CITY OF ALBUQUERQUE

**Re: GAHP Casa Feliz
421 Espanola Street SE
Request for Permanent C. O. – Not Accepted
Engineers Stamp Date 12/18/15 (L19D073F)
Certification dated: 7/18/2017**

Based on the Engineer's Certification provided in your submittal received 7/18/2017, Hydrology cannot approve the issuance of the Certificate of Occupancy until the following comments are addressed:

RIP-RAP CHANNEL SECTION B-B

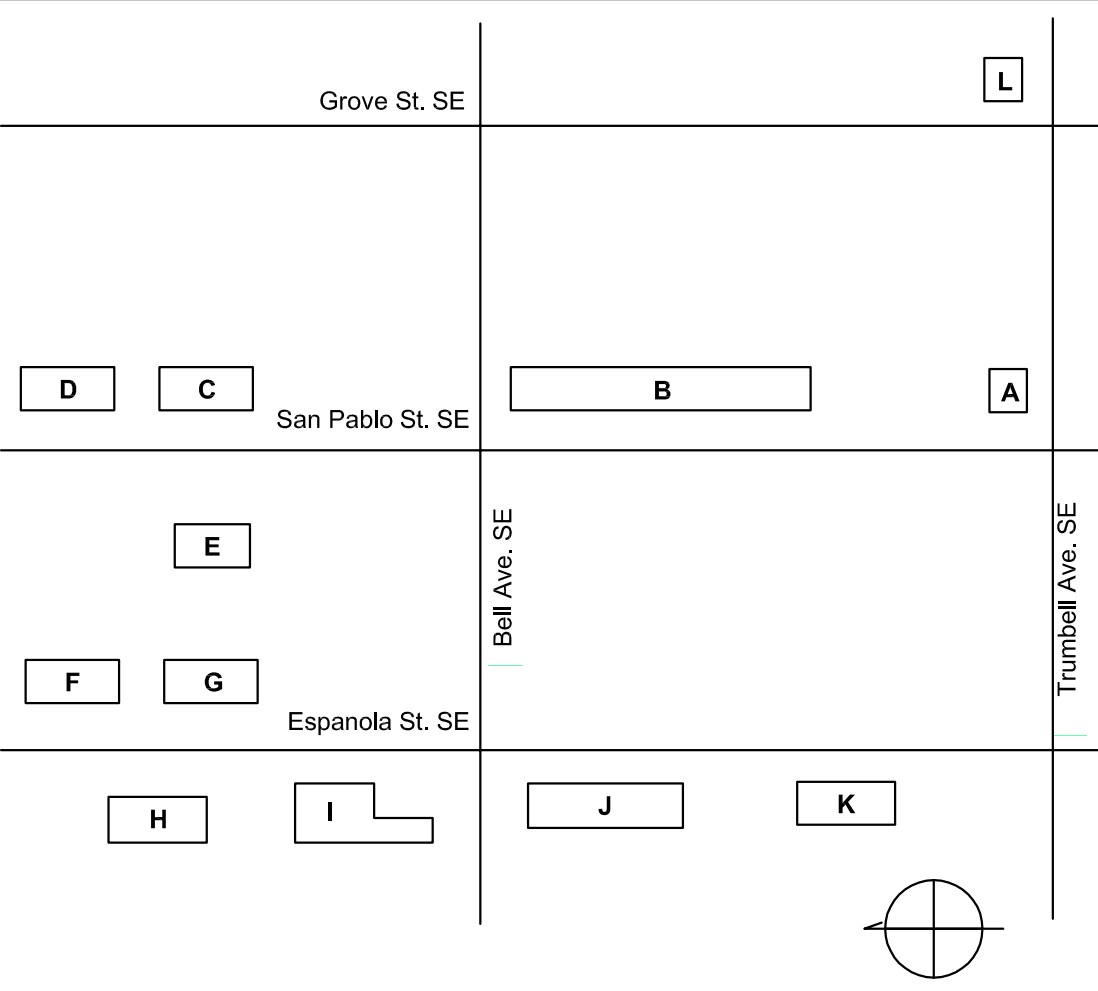
1. Even though your certification and associated survey claims a 6" deep channel on the south side of the site, at our site meeting on 7/20/2017 it appeared that most of that depth is loose landscape rock that won't hold water. So the Grading Plan must be revised and resubmitted to hydrology to include a design of a wall or curb along the south property line as necessary to prevent cross lot drainage. The revised plan should include a new engineer's stamp date.
2. The revised plan should also include a cross-section through the swale and property line and show this sit 1' higher than the adjacent site as shown at section D on the surveyed sections. Manning's "n" value in the channel calculations also needs correction from 0.025 to 0.045 for rip-rap.

CASA FELIZ APTS.
CLIENT: TOFEL CONSTRUCTION
INFRASTRUCTURE AS-BUILT
CREW: LRC
DATE: 7/5/17

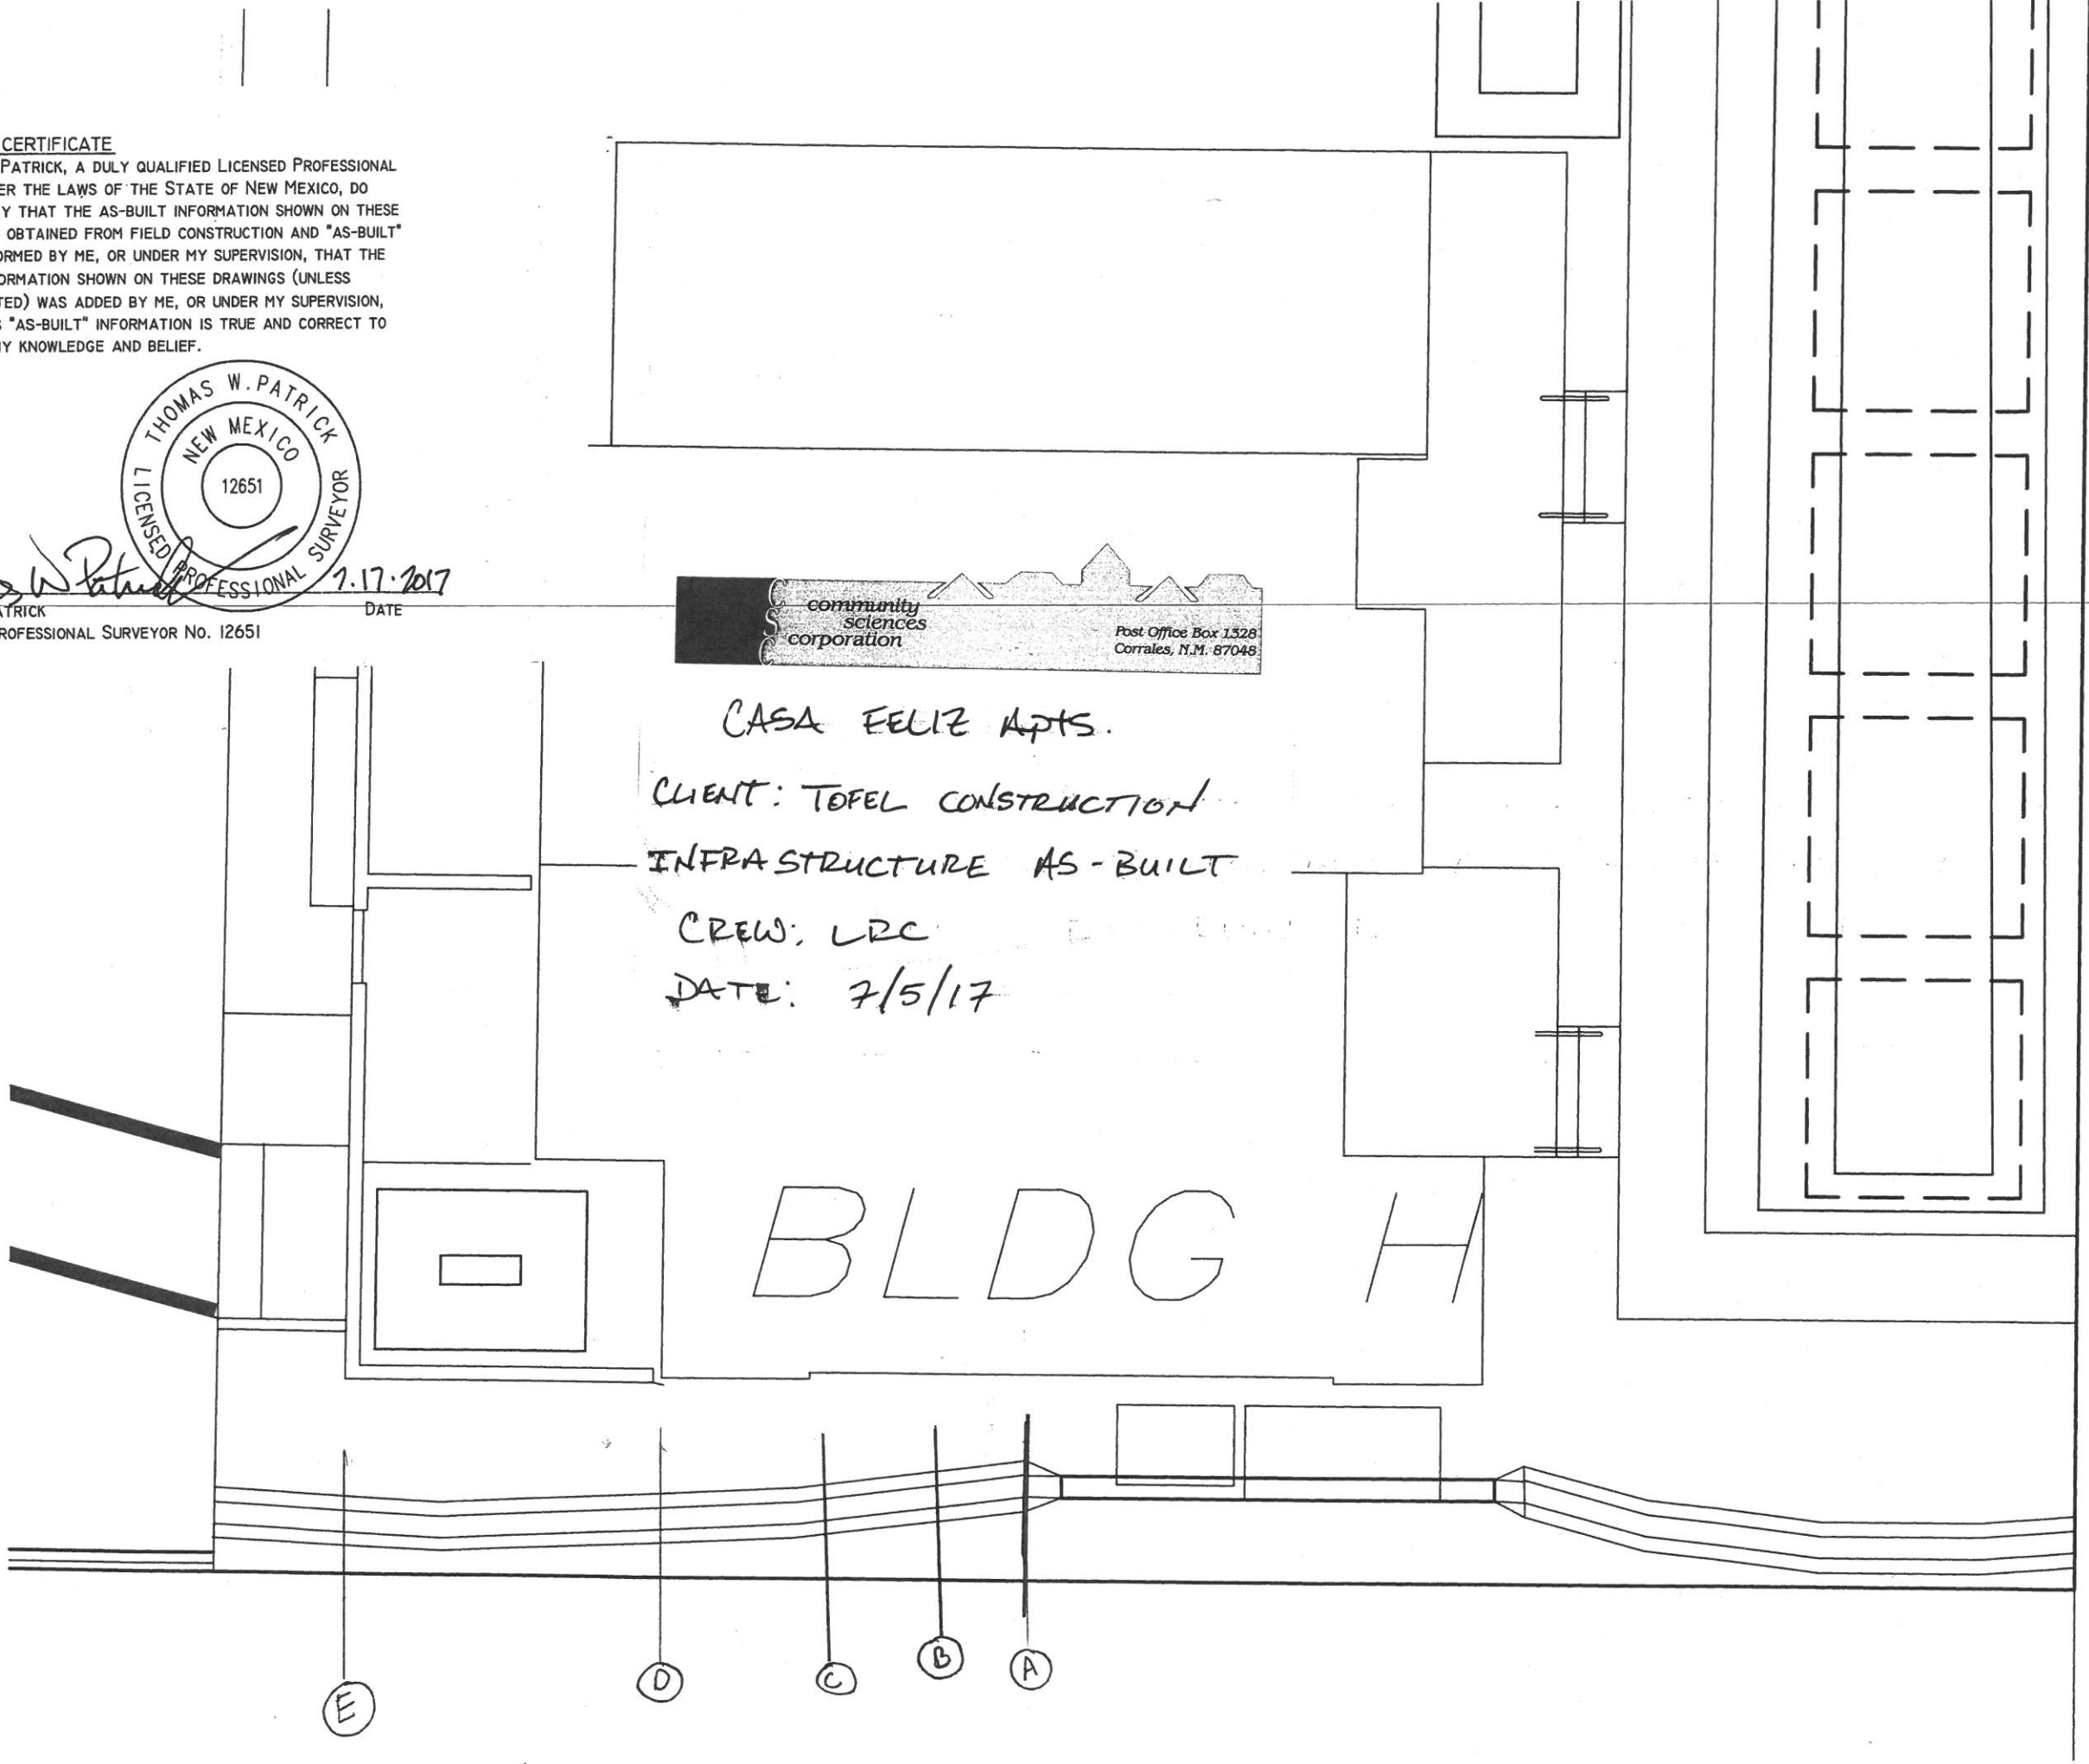
2. As-built survey information should be added to the plan to include spot elevations throughout the parking lot, the swale , and the finished floor elevations as well as the top of the new wall to be added on the south side of the property.
